GSM SERVICE SUPPORT GROUP	2002.12.09
Level 3 Schematics	Rev. 1.0
Dual Band T720 / T720i 900/1800MHz	P7.4
Ralf Lorenzen-Scheil, Michael Hansen	Page 1 of 3

Dual Band T720i/T720j 900/1800MHz 8487770N01 P7.4

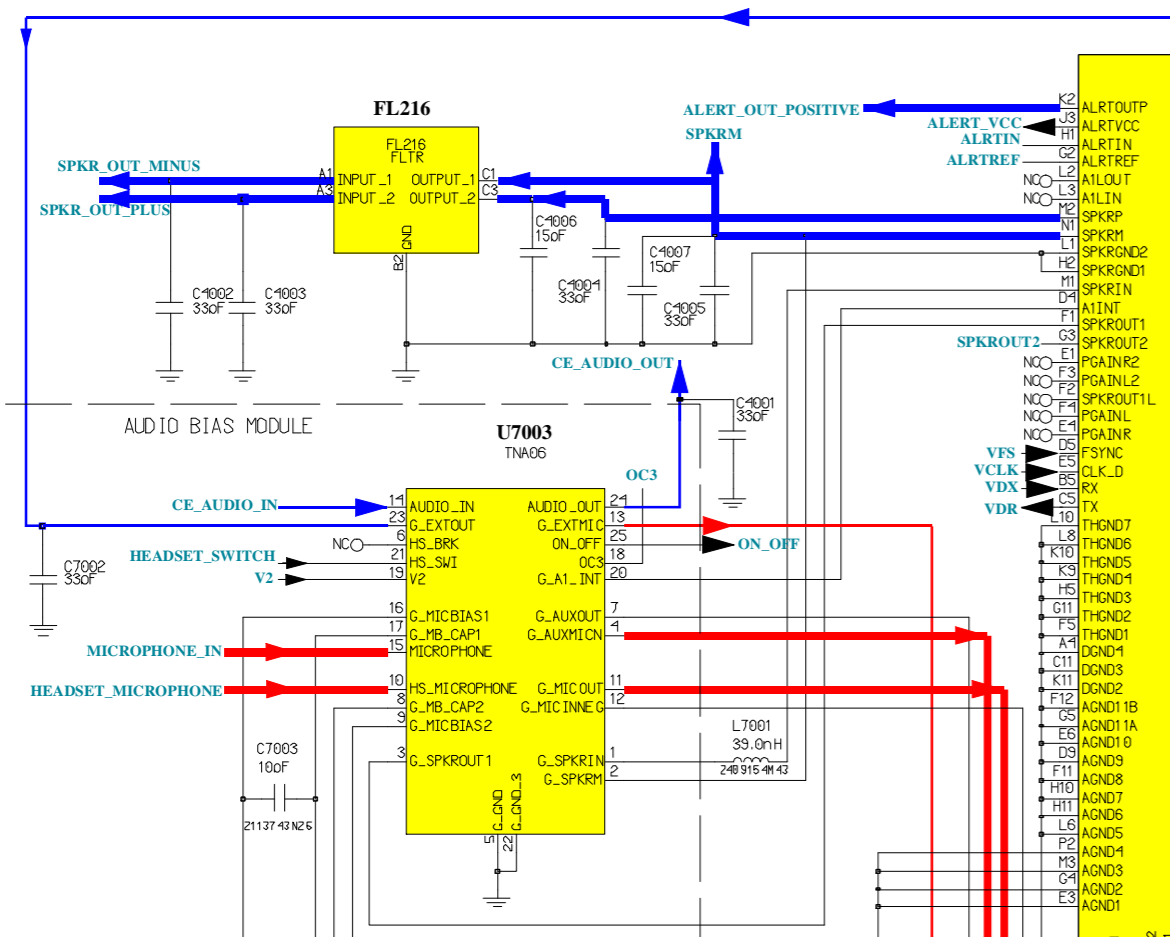
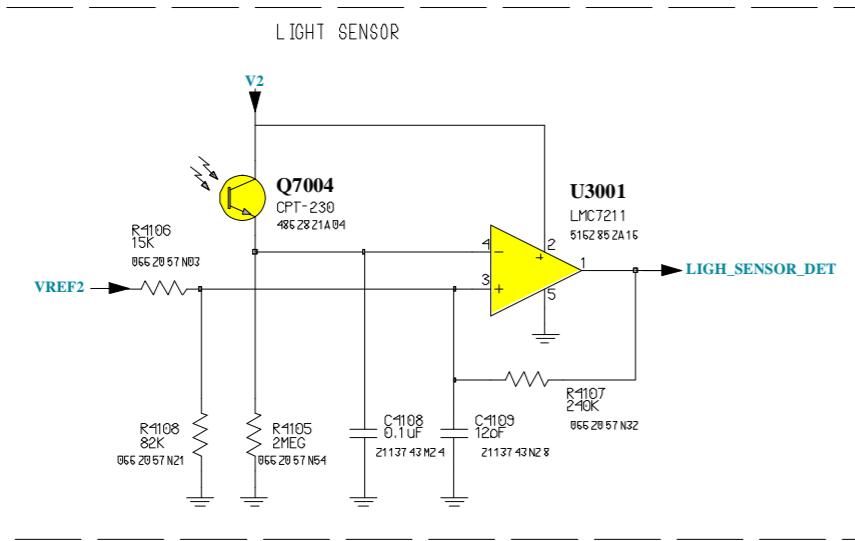
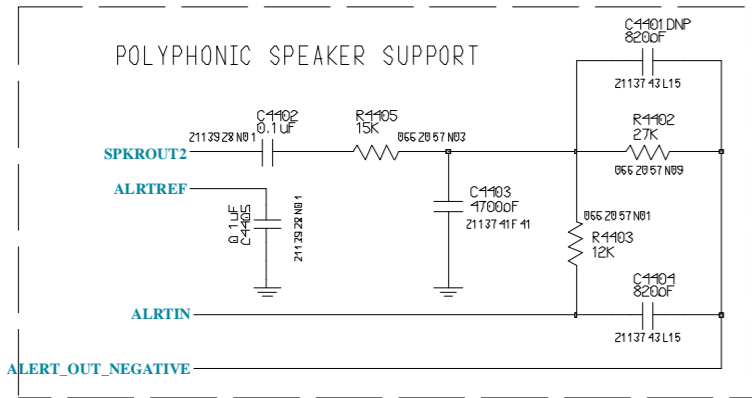
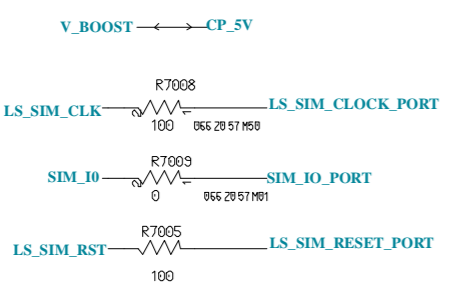
- 9-24-01 Added high voltage prog res to flash ckt R2201
- 9-24-01 Split C1101 into two caps C1101 and C1102
- Removed stacked memory and replaced with 64mbit Whitcliff flash and 16 mbit Samsung SRAM

- 9-24-01 Replaced R7011NDP with placed res R7011 and deleted loop around it
- 9-24-01 Added bypass cap to SRAM C7138
- 9-24-01 changed CS1 from EIM_CS2 to SR_CSN

- 9-24-01 Connected NC1 from U2003 to A20
- 10-08-01 Added cap c1013 to GCAP_13MHZ_CLOCK line
- 01-18-02 Replaced U2003 with a 16 mbit part 5185353064
- 01-21-02 Replaced C1006 and C1008 with dual cap C1006

- 01-21-02 Replaced C1101 and C1102 with dual cap C1101
- 01-21-02 Replaced C1004 and C1005 with dual cap C1004
- DELETED TP204, TP205
- 03-14-02 Removed R2201, R1401, R7011

- 03-14-02 Connected INT2_PC14 TO URTS1_PA13 lines of Patriot
- 03-20-02 REPLACED PATRIOT WITH NEW PART D22
- 03-20-02 IMPLEMENTED JTAG TRU CE_BUS CONNECTOR. ADDED TP_MUX_CTL

- 04-23-02 ADDED LIGHT_SENSOR_DET LINE
- 6-11-02 Added DISP_RESET_N signal to rest display
- 6-11-02 Moved C1013 from GCAP_32KHZ_IN to GCAP_13MHZ_CLOCK for desense

- 6-11-02 Removed R1004
- 6-12-02 Added R1401 for desense
- 6-15-02 Updated Q1000 with 4809605E08
- 6-24-02 Added R1402 for Multitole phone flash issue
- 6-27-02 changed R1401 to 1.2 K for desense

- 7-15-02 changed R1401 to 1k and C1013 to 33 pf for desens

LINEAR VOLTAGE REG AND SWITCHING SUPPLIES

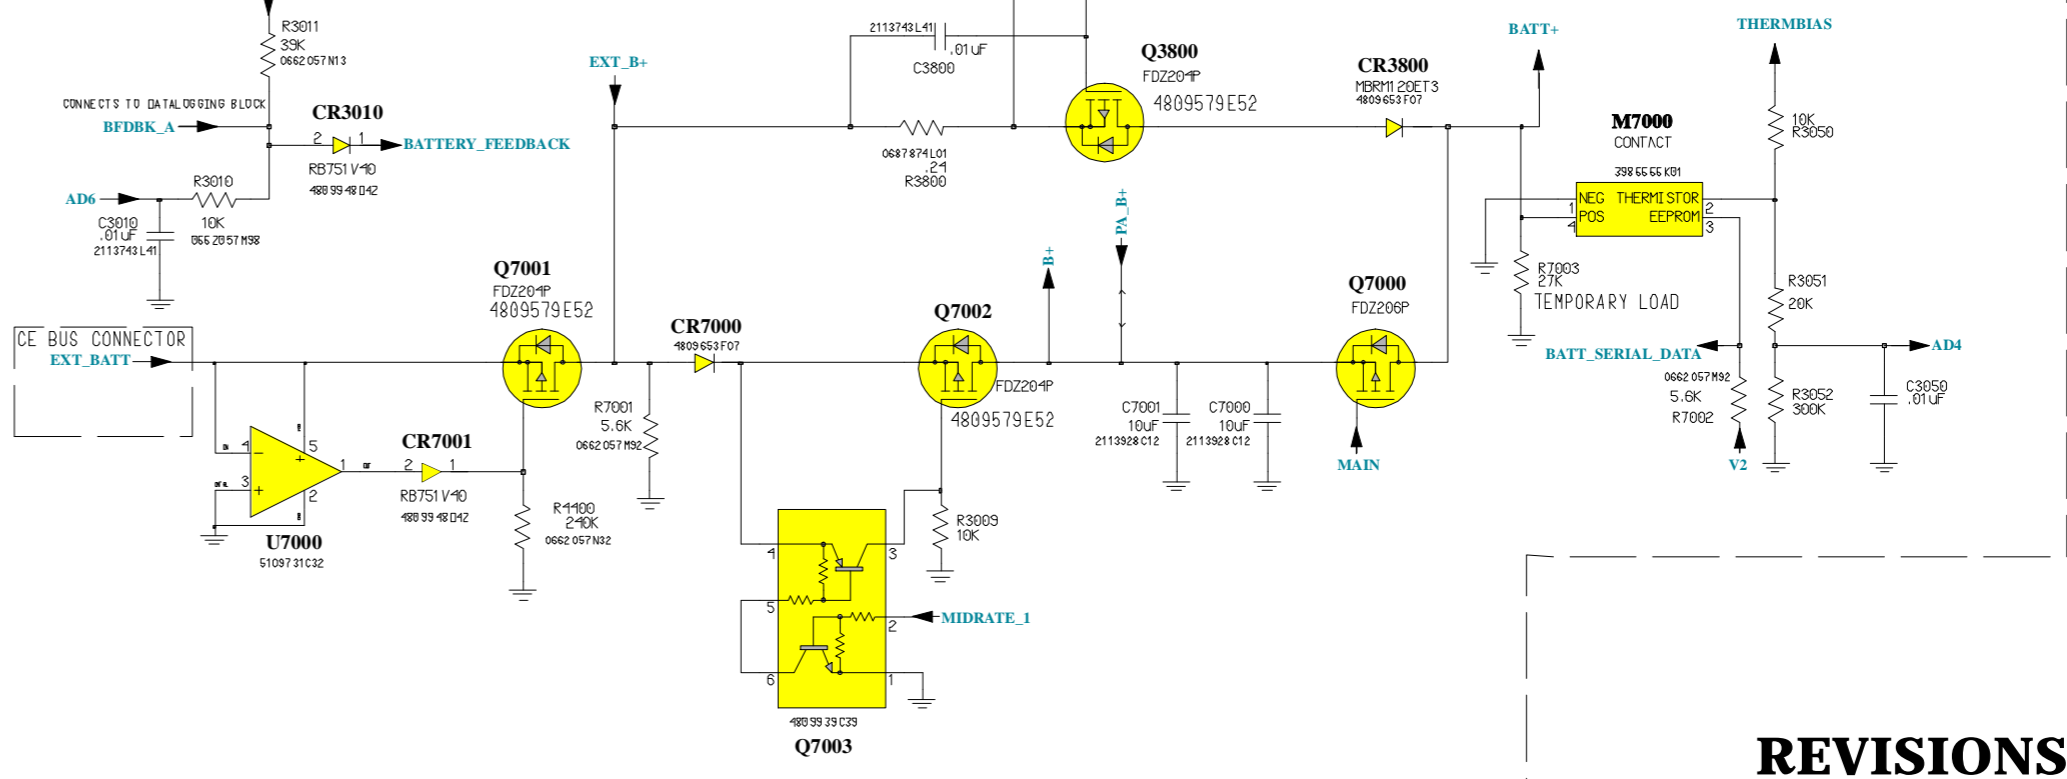
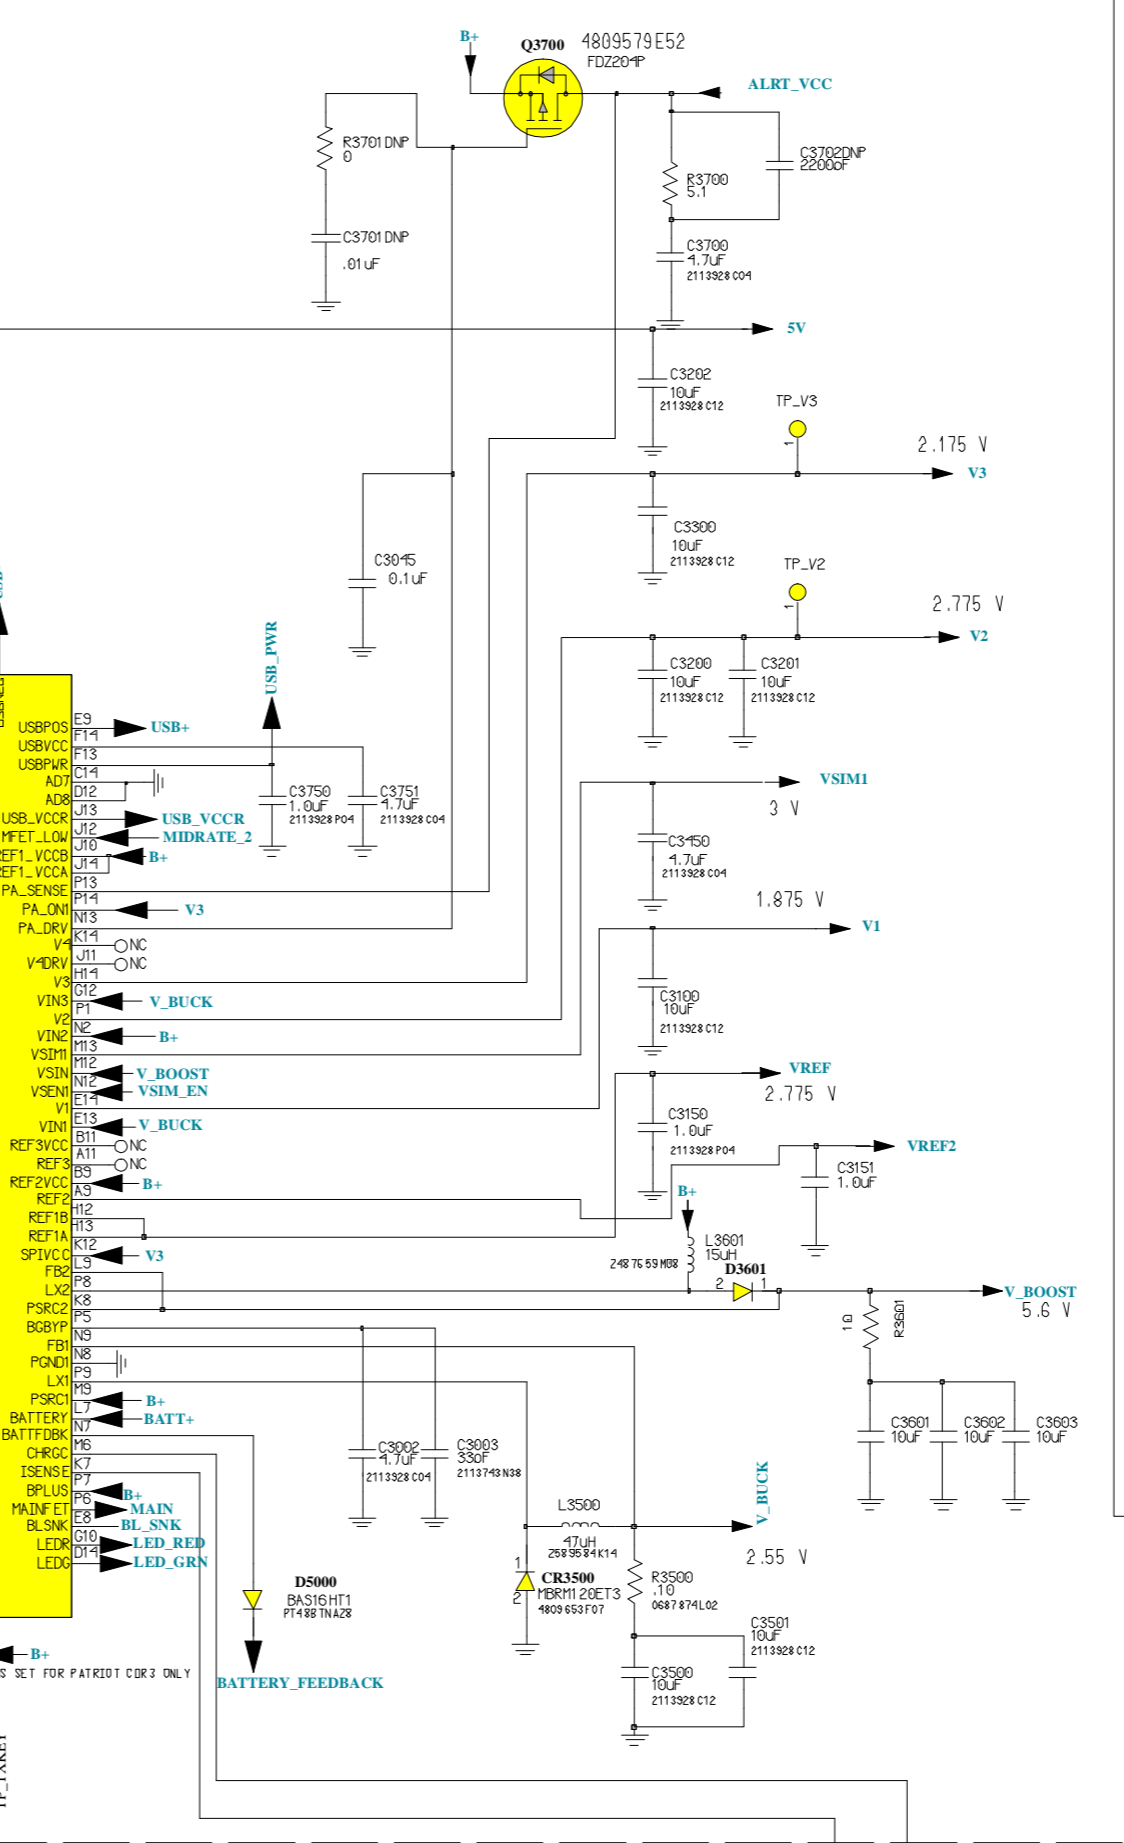
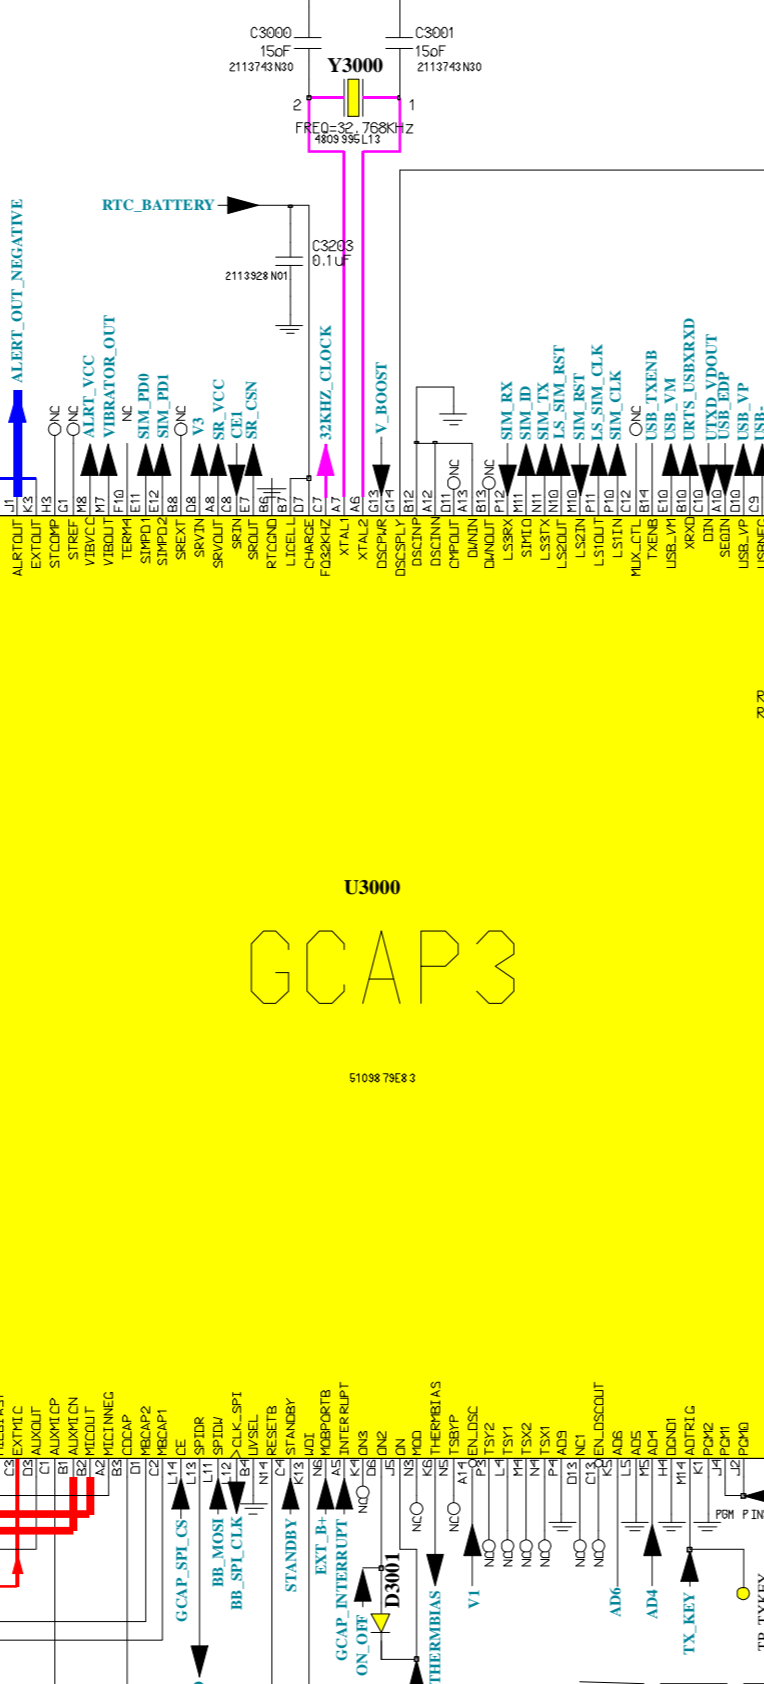
- 9-24-01 Added 1 no preload res to V1 R3002DNP
- 9-24-01 Added 1 no pre-load res to V2 R3002DNP
- 9-24-01 Added current sensing res to VBUCK R3013
- 9-24-01 Added current sensing res to VBOOST R3012

- 9-24-01 Removed current sensing res from ALERT_VCC R3004
- 9-24-01 Removed current sensing res from 5V R3005
- 9-24-01 Removed current sensing res from V3 R3006

- 9-24-01 Removed current sensing res from V2 R3007
- 9-24-01 Removed current sensing res from V1 R3008
- 9-24-01 Split C3041 into two caps C3041 and C3043

- 9-24-01 Split C3040 into two caps C3040 and C3042
- 9-24-01 Split C4004 into two caps C4004 and C4005
- 9-24-01 Added D3001 to connect ON_OFF to POWER_END_KEY

- 9-24-01 Change layout LED from 480946B12 to 480946B17 Interface
- 9-24-01 Change LED from 480946B12 to 480946B17 Interface
- 56Check J4100DNP in V_NE J4101 T720 0909195E01 Motorola95E01 Interfaces Interface

- 57Change Ref.Des. U5001 to U5000 Interfaces
- 58Change Ref.Des. U5002 to U5001 Interfaces
- 59Change ref des U7011 U7003 GCAP
- 60Change C3201 from 2113928C04 Cap 4.7uF to 2113928C12 Cap 10uF used by V_NE GCAP

- 61Change C3202 from 2113928C04 Cap 4.7uF to 2113928C12 Cap 10uF used by V_NE GCAP
- 62Change C7001 from 2113928C04 Cap 4.7uF to 2113928C12 Cap 10uF used by V_NE GCAP

- 63Change C4000 from 0662057M98 Res 47k to 0662057M98 Res 240k used by V_NE GCAP
- 64Change C7002 from 0662057M98 Res 4.7k to 0662057M98 Res 5.0k used by V_NE GCAP

- 65Change Ref.Des and part # from C3040 2113743M24 Cap 0.1uF to C4107 2113928N01 Cap 0.1uFGCAP
- 66Change Ref.Des. C3041 to C4106 2113743M24 Cap 0.1uF GCAP

- 67Change Ref.Des. C3042 to C3041 2113743M24 Cap 0.1uF GCAP
- 68Change Ref.Des. C3043 to C3041 2113743M24 Cap 0.1uF GCAP
- 69Change Ref.Des. C3501 to C3502 2113928C12 Cap 10uF GCAP

- 70Change Ref.Des. C3502 to C3501 2113928C12 Cap 10uF GCAP
- 71Change Ref.Des. C3503 to C3502 2113928C12 Cap 10uF GCAP
- 72Change Ref.Des. C3504 to C3503 2113928C12 Cap 10uF GCAP

- 73Change Ref.Des. C3505 to C3504 2113928C12 Cap 10uF GCAP
- 74Change Ref.Des. C3506 to C3505 2113928C12 Cap 10uF GCAP
- 75Change Ref.Des. C3507 to C3506 2113928C12 Cap 10uF GCAP

- 76Change Ref.Des. C3508 to C3507 2113928C12 Cap 10uF GCAP
- 77Change Ref.Des. C3509 to C3508 2113928C12 Cap 10uF GCAP
- 78Change Ref.Des. C3510 to C3509 2113928C12 Cap 10uF GCAP

- 79Change Ref.Des. R925 to R3050 0662057M98 Res 10k GCAP
- 80Change Ref.Des. R926 to R3051 0662057M98 Res 20k GCAP
- 81Change Ref.Des. R927 to R3052 0662057M98 Res 30k GCAP

- 82Change audio Jack J4000 from 0987837L02 to 0987837L04 interfaces
- 83Change V3000 4809955L10 to new improved part 4809955L13 GCAP
- 84Change R7003 R7003DNP

- 85Change audio module temp part number to real one 9188695K03 GCAP
- 86Change L216 temp number to real one 4809525L03 GCAP
- 87Change L4000 temp number to real one 4809525L04 interfaces

- 88Change all 0.1 uF caps with part 2113743M24 to 2113928N01 to use one common part GCAP
- 100*Change components from 2113947A04 to 2113947B05
- 01-17-02 replaced V3000 with new part 4809955L13

- 01-17-02 Reworked pin 4 of 07003 to pin 2 of CR7000
- 01-17-02 Removed R3012 and R3013 and replaced with runner
- 01-17-02 Added R5007 from pin 5 to gnd and eliminated connection to pin 6 of GCAP audio module

- 01-17-02 Replaced CR3010 and CR7001 with dual diode 4809306E05
- 03-05-02 Change AGND to GND for buzz reduction
- 03-05-02 Removed R3002DNP, R3001DNP preload res to GCAP res

- 03-05-02 Added C7003 and L7000 for buzz reduction
- 03-14-02 PG added L1004, R4105, and C4108 for light sensor ckt
- 03-14-02 PG Added L5000 for BUZZ
- 03-14-02 PG Added C4101 and C4104 to MBCAP1 and MBCAP2 pins of GCAP for BUZZ

- 03-14-02 PG Replaced input to VIB reg with ALRT_VCC
- 03-20-03 CHANGED R4402 FROM 43K TO 22K
- 03-21-02 Added C4001, C4002, and C4003 for BUZZ
- 03-22-02 rewired connection to headset speaker, added SPKRM signal

- 04-09-02 Rotated 07003 180 deg. C31 symbol was wrong
- 04-11-02 Changed C4403 to 620k of and C4404 to 330 of to increase bandwidth of poly sokr
- 04-23-02 UPDATED LIGHT SENSOR CKT WITH THE COMPAT108

- 5-9-02 Changed C4403 to 4700 of, C4404 to 820 of, C4401 to DNP, R4402 to 27k, R4403 to 12k
- 5-9-02 Changed L7000 to C7004 0.1 uF
- 5-9-02 Removed C410 DNP

- 5-9-02 Added C3042 and C3043
- 5-14-02 Updated L3601 to 2487659M08
- 5-17-02 Changed R4106 from 10k to 15k and R4108 from 4.7k to 82k R4107 from 100k to 240k

- 5-24-02 Added R5008DNP and D5000 for heat problem
- 5-25-02 CHANGED C7004 TO L7000 47 nH
- 6-5-02 Added E304 for WDOG test susoort
- 6-15-02 Replaced R7004 with R7008 and R7009

- 6-15-02 Replaced C3450 with a 4.7 uF
- 6-17-02 ADDED C3045DNP
- 6-21-02 Added C4006 and C4007 for buzzzzz
- 6-28-02 placed C3045 at PA_DRV pin for noise reduction.

- 6-28-02 add C7002 for buzz.
- 7-9-02 deleted C508dnp
- 7-10-02 Added C3702dnp, r3701dnp to stabilize PA_drive
- 7-15-02 changed C4104 to dnp for buzz
- 7-15-02 changed R7009 to M01 for SIM issue
